Proposed Code Case and Code change to ASME Section XI, Appendix VIII, Supplement 11

**SUPPLEMENT 11 — QUALIFICATION
REQUIREMENTS FOR FULL STRUCTURAL
OVERLAID WROUGHT AUSTENITIC
PIPING WELDS**

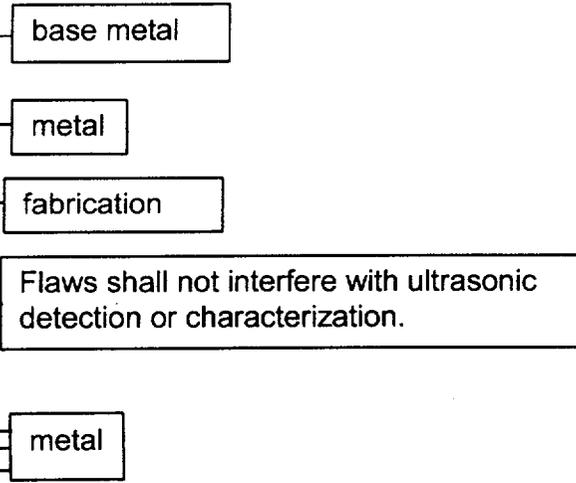
The major difficulty with the current Supplement 11 is that it requires that all flaws be cracks. As illustrated below implanting a crack requires excavation of the base material on at least one side of the flaw. While this may be satisfactory for ferritic materials, it does not produce a useable axial flaw in austenitic materials because the sound beam, which normally passes only through base material, must now travel through weld material on at least one side. For this reason paragraph 1.1(d)(1) was modified to allow for the use of alternative flaw mechanisms under defined conditions.

(1) At least 20% but less than 40% of the flaws shall be oriented within ± 20 deg. of the pipe axial direction. The remainder shall be oriented circumferentially. Flaws shall not be open to any surface to which the candidate has physical or visual access. ~~The rules of IWA-3300 shall be used to determine whether closely spaced flaws should be treated as single or multiple flaws.~~

(a) A minimum of 70 percent of the flaws in the detection and sizing tests shall be cracks. Alternative flaw mechanisms, if used, must provide crack like reflective characteristics and be limited by the following:

(1) Alternative flaws must be limited to the case where implantation of cracks precludes obtaining a realistic ultrasonic response.

(2) Alternative flaws must be semielliptical with a tip width of less than or equal to 0.006 inches.
